**SERVICE BULLETIN**

**APPLICABILITY:** 2019MY Ascent **NUMBER:** 05-72-19R  
**SUBJECT:** Squeak / Creaking Sound from Rear Suspension **DATE:** 12/10/19  
**REVISED:** 12/06/21

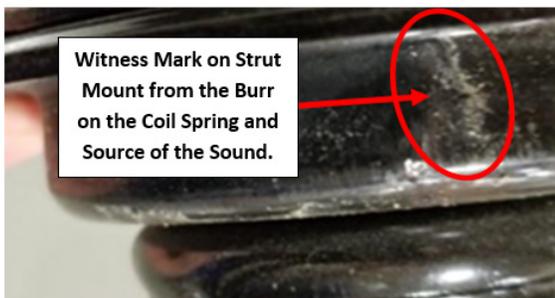
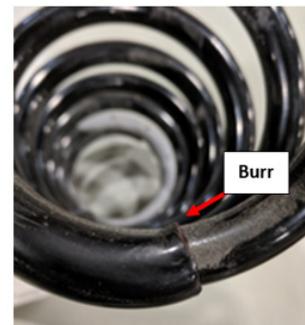
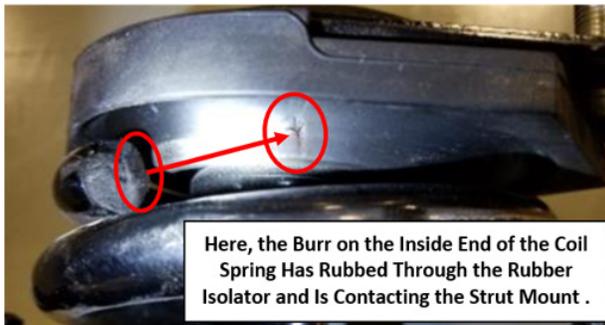
This bulletin addresses isolated concerns of a squeaking / creaking -type sound from the rear suspension. The condition is caused by a burr on the end of the coil spring winding produced with an end gap which was out of specification. This allowed the burr to make contact with the mount. Over time, the burr, which is characteristic result of the manufacturing process, can penetrate the rubber isolator and come into direct contact with the strut mount as shown in the photos below. This contact creates the sound described. Should this occur, both the mount and coil spring must be replaced. **NEVER attempt to grind or otherwise alter the burr on the new or original equipment coil spring** or repair any contact marks with paint or other coatings. Replace the affected parts with new ones.

Improved coil springs were incorporated into production as per the table below:

- The rear coil spring part numbers are unchanged. All inventory was replaced with the new parts.
- **NEVER** attempt to grind or file the burr away. This will reduce the corrosion resistance of the spring.
- The nuts listed in the table above are both **one-time use** items and **MUST** be replaced at reassembly.
- The isolator is part of the strut mount assembly and is not available separately.
